PZ&B Staff Combination Memorandum: Landmarks Preservation Commission and Town Council

SUBJECT: COA-24-0022 (ZON-24-0055) 120-132 N COUNTY RD—
Palm Beach Synagogue

MEETING: NOVEMBER 13, 2024, TC
NOVEMBER 20, 2024, LPC

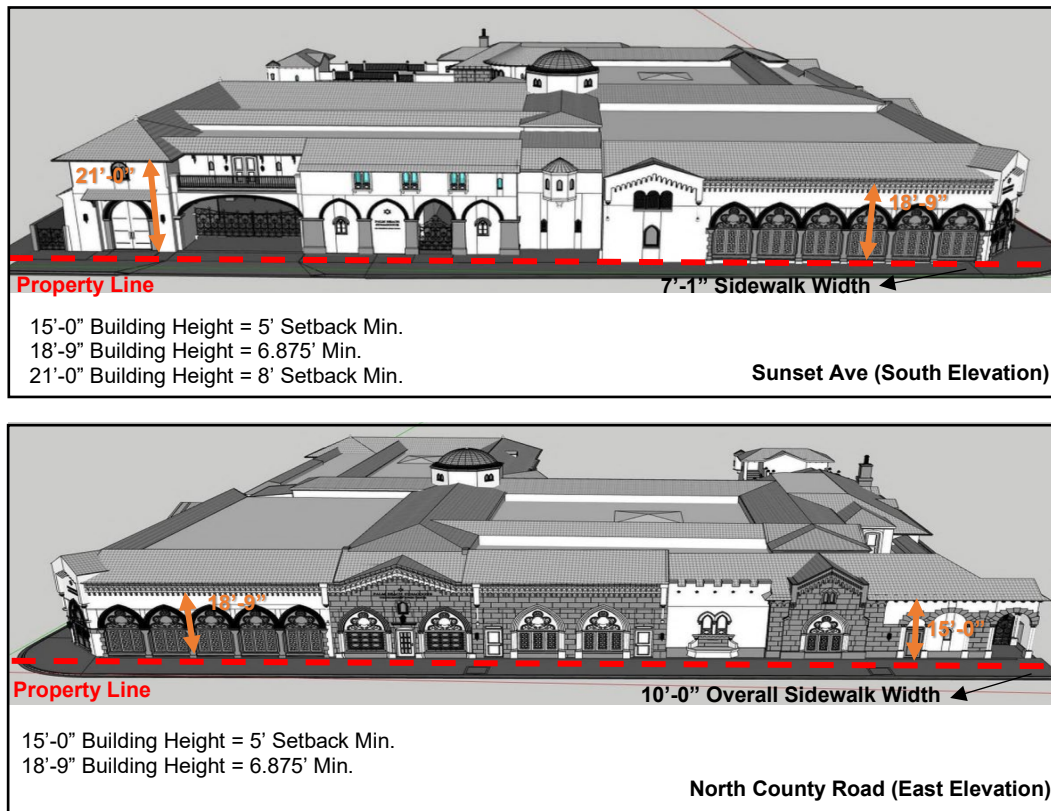
For buildings in excess of 15'-0" in height, all minimum yard requirements are increased by one foot for each two feet of building height, or portion thereof, exceeding 15'-0". The landmarked facades are the primary architecturally significant elements of the structures that are required to be retained. The existing synagogue is sited at the corner with a nonconforming front (south) setback

of 0.2' along Sunset Avenue. Along N County Rd, the existing synagogue is sited with a setback of 5'-0" which is non-conforming for the portion of the facade that exceeds a height of 15'-0". The variance applies to the existing portion of the building which is landmarked and the new additions. The required front yard setback along Sunset Ave ranges from 6.875' to 8' based on the portions of the building that exceed 15'-0" in height. Likewise, along N County Rd the required setback ranges from 5' to 6.875'.

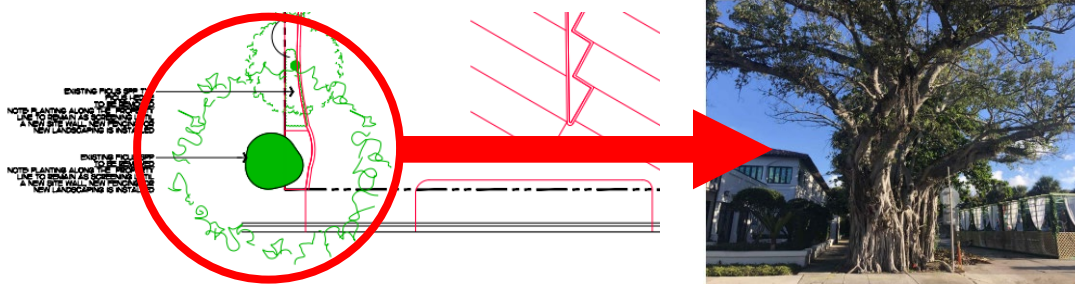
As it pertains to **Variance #3**, a variance to reduce the minimum required front yard landscape open space. The site has a nonconforming front yard open space, and due to the amount of demolition exceeding 50%, all nonconforming elements must be vested. The retention of the existing façade of the corner synagogue landmarked building, creates challenges in meeting the required 25%. The applicant has provided green planting areas in those portions of the new construction fronting the roadways—most notably along Sunset Ave. The proposal does improve the legal non-conformity of front yard open space along the Sunset Ave frontage from 10.6% to 18.05% and along the N County Road frontage from 0.5% to 15.2%. Staff has no objections to variance #3, but perhaps the applicant can further study areas that additional green space can be

incorporated on site, particularly at the northeast edge along the new construction where the social hall is located by setting back the building in selected areas.

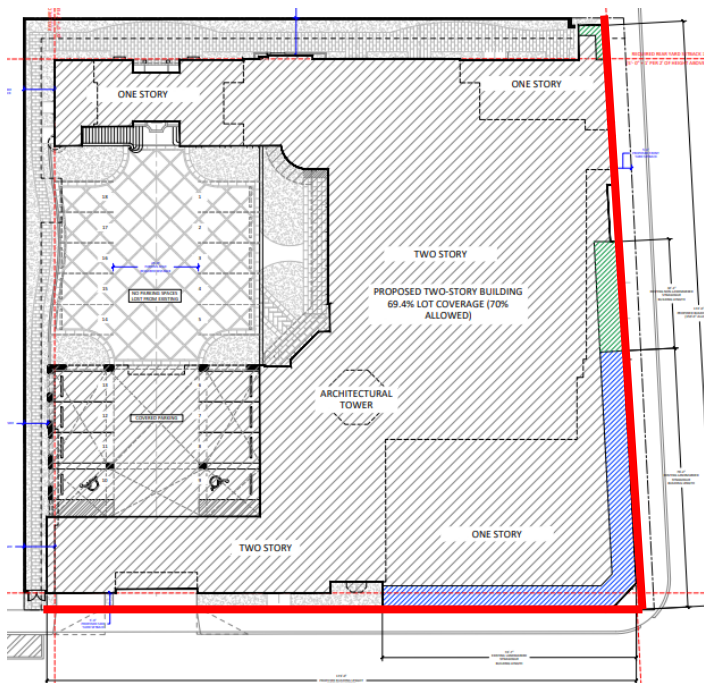
Variance #4 requests to exceed the maximum building length of 150'-0" maximum building length permitted; the request pertains to both sides (east and south) for the proposal of alterations and substantial additions of the corner building of N County Road and Sunset Ave. Along N County Road, the existing landmarked synagogue building has a 76'-2" long frontage plus an additional 32'-2" of non-landmarked portion of the synagogue. The other structures (formerly occupied by Chez Jean-Pierre Bistro) has a 63'-8" long frontage. This structure was approved to be demolished and is proposed to be replaced by an attached new addition. The variance along the east (N County Road) is to exceed the allowance by 22'-0" for a total frontage of 172'-0". This will extend the building nearly the entire linear length (174') of the eastern side of the site which will provide for a continuous urban edge, an optimal urban condition along commercial main streets. For visual reference the landmarked portion of the proposal is highlighted in blue in the diagram to the right.

Red Loading Zones are to the west of the site in front of 223 Sunset Avenue.

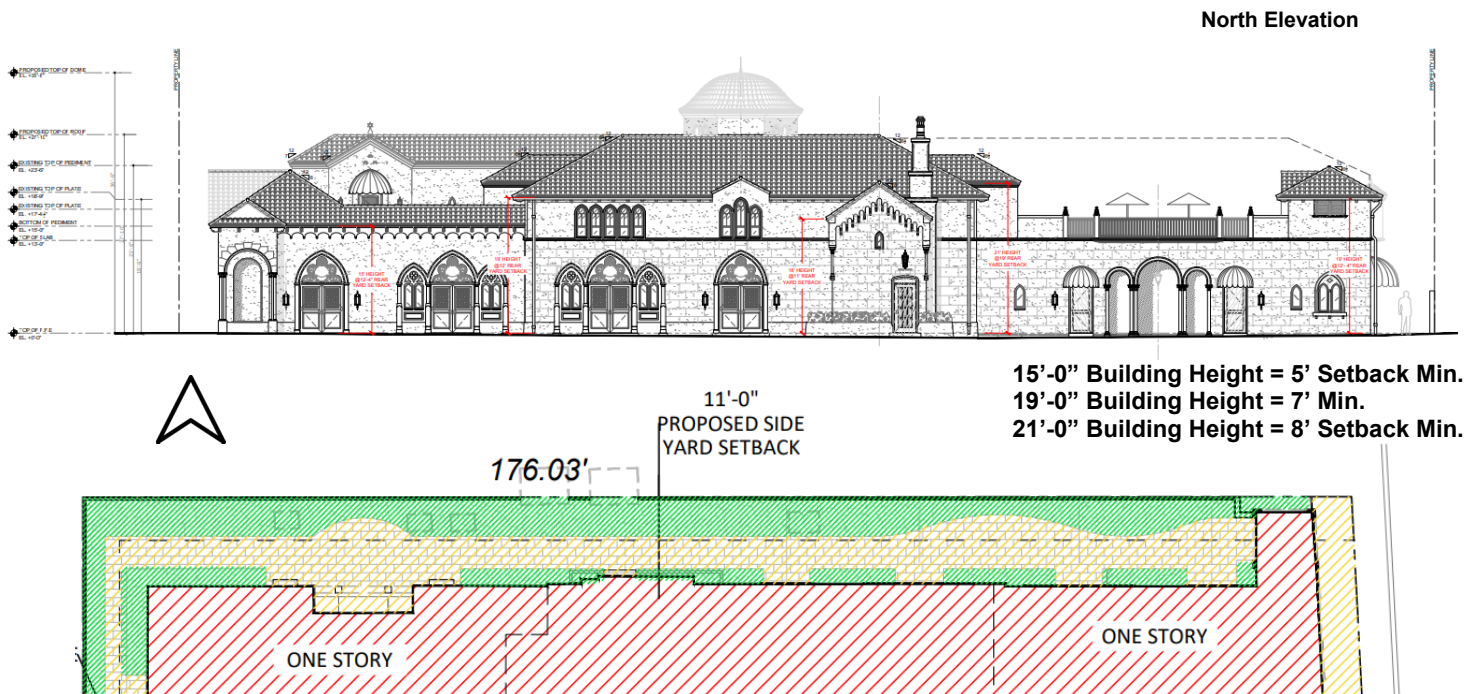
As it pertains to **Variance #7**, to not provide one required loading space for the religious facility, a request is made to grant this variance as the property has been in operation without one for nearly 100 years without a loading space. The code does require a minimum of two (2) dedicated loading berths (12' x 25') on-site for this sized program. If the site plan is approved, a non-dedicated on-site loading space can be provided for off-hours loading service that does not conflict with event operations and the proposed parking. Otherwise, the facility can utilize one of the existing

designated commercial loading spaces shown below located to the west of the subject property along Sunset Avenue.

West Elevation

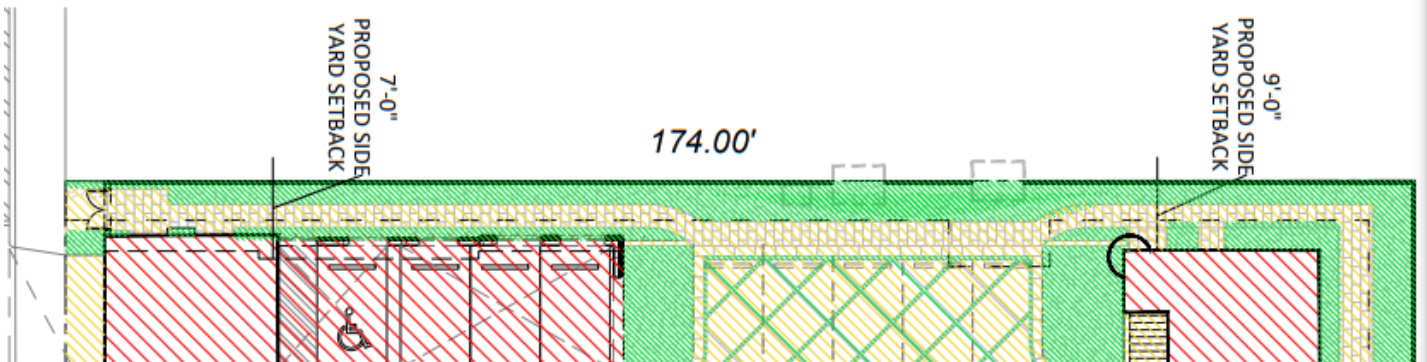
Variance #9 to reduce the minimum required rear yard (west) setback ranging from 7' in lieu of the required setback of 13'. The additions will provide a setback that ranges from 7' to 9'. An increased setback above 15 feet of height also applies to the rear setback areas, however, the

minimum setback here is 10 feet. Based on building heights, the required setback ranges from 12.166' to 13'.

15'-0" Building Height = 10' Setback Min.
 19'-0" Building Height = 12' Min.
 19'-4" Building Height = 12.166' Min.
 21'-0" Building Height = 13' Setback Min.
